**REZONING,
PLANNED UNIT DEVELOPMENT
SIDEWALK WAIVER &
SUBDIVISION STAFF REPORT**

APPLICANT NAME Orchard Baptist Church

LOCATION 6960 Overlook Road
(Southeast corner of Overlook Road and Howells Ferry Road).

CONTEMPLATED USE Rezoning from R-1, Single-Family Residential, and B-2, Neighborhood Business, to B-1, Buffer Business, to eliminate split zoning in a proposed one-lot subdivision for a church. Planned Unit Development Approval to allow four buildings on a single building site, and Subdivision approval to create one legal lot of record.

SITE PLAN

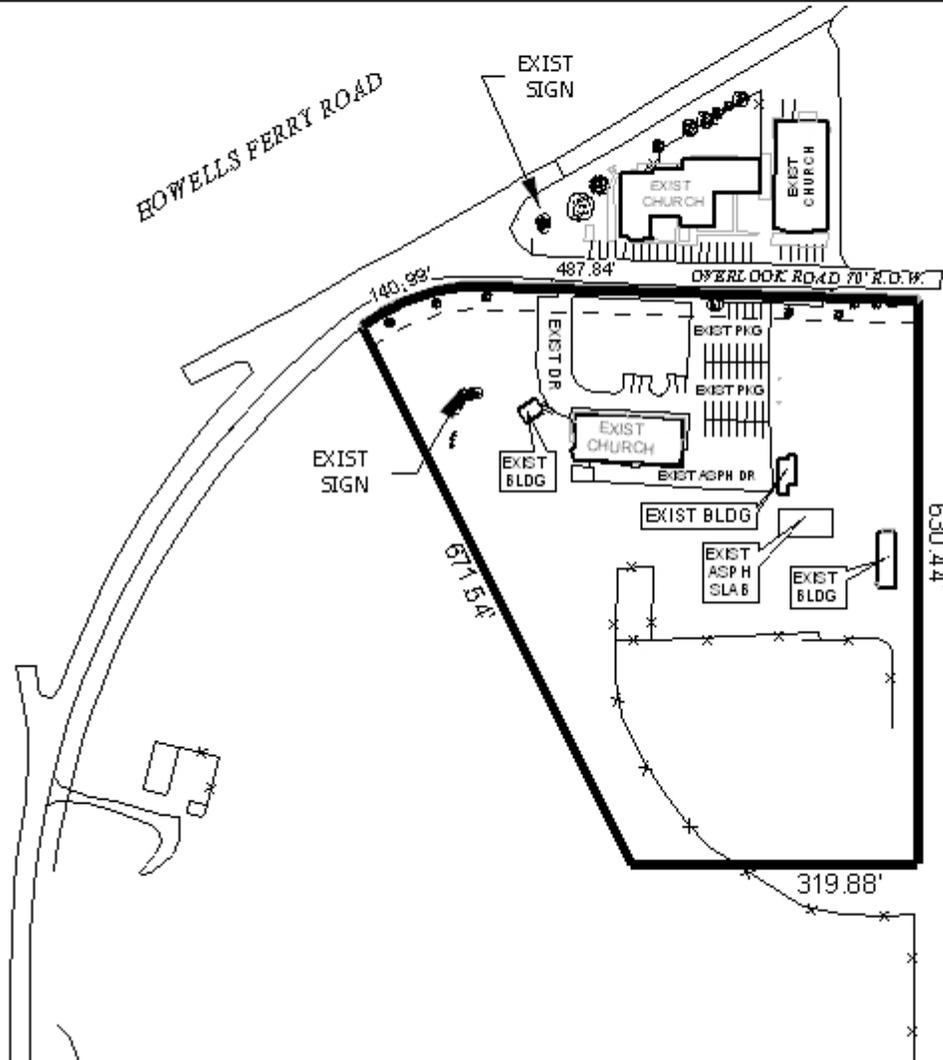
The revised site plan illustrates a proposed expansion of parking facilities, which will provide a total of 116 parking spaces on site. The plan indicates that the seating for the church is 500, requiring a minimum of 125 parking spaces. Given the layout of the proposed expansion, it appears that an additional 9 spaces could easily be accommodated in the southern portion of the expanded facilities.

Another issue is that the plan reflects a 320'± continuous curb cut. As shown on the plan, the curb cut would effectively allow direct ingress and egress for 11 parking spaces, and only has an 18-20' wide "formal" entrance into the parking facility. While it appears that this access may be existing, the extensive expansion to the parking facility should be adequate to require modifications to the curb cut and entrances.

The applicant has submitted a revised plan that reflects the church properties across Overlook Road, however there are still several issues that have not been addressed. The revised plan does not accurately depict property lines for the church property on the North side of Overlook Road; does not include revisions to access for the property on the South side of Overlook Road, as were conditioned by the rezoning and subdivision approvals; does not include additional parking spaces to meet minimum requirements; proposes parking spaces that are not accessible due to a power pole and guy wire. Additionally, as noted for the November 15th meeting, the site on the North side of Overlook consists of multiple parcels and should have had a subdivision application.

Additionally, the property on the North side of Overlook is shown to have 20+ parking spaces that appear to be located at least partially in the right-of-way, or at a minimum have all their maneuvering in the right-of-way. As these parking facilities are existing, removal at this time may not be justified based on the scale of the project before the Commission. However, any future expansion/construction on either site should require elimination of those spaces, including removal of paving material, installation of appropriate curb cuts (to be approved by Traffic Engineering), installation of landscape materials and construction of a city standard sidewalk.

Subdivision: *Based on the preceding, the plat is recommended for Tentative Approval, subject to the following conditions:*

1. correction/depiction of dimensions along the South and East property lines, to coincide with those from Overlook Station Subdivision;
2. placement of a note on the final plat stating that the site is limited to a maximum of three, 24' wide curb cuts, size, size, location, and design to be approved by Traffic Engineering and conform to AASHTO standards;
3. removal of extraneous paving materials from the continuous curb cut and installation of landscape material, to coincide with redesigned and approved 24' wide curb cuts.

Planned Unit Development: Based upon the preceding, this application is recommended for HOLDOVER until the December 20 meeting to allow the applicant to revise the plan to include all properties associated with the church and used for church functions (parking, services, classrooms, etc), and illustrate revisions to parking facilities as referenced in the remarks section of this report.

Recommendation *Based on the preceding, it is recommended that this application be approved subject to the following conditions:*

- 1. any future improvements to the site(s) will require a new PUD application;*
- 2. future improvements will necessitate compliance with conditions placed on the rezoning and subdivision; and*
- 3. future improvements to property on the North side of Overlook will also necessitate a subdivision application to incorporate all parcels into one legal lot of record (and dependent upon when the parcels were established, may also require inclusion of the remainder of the parcel(s)).*
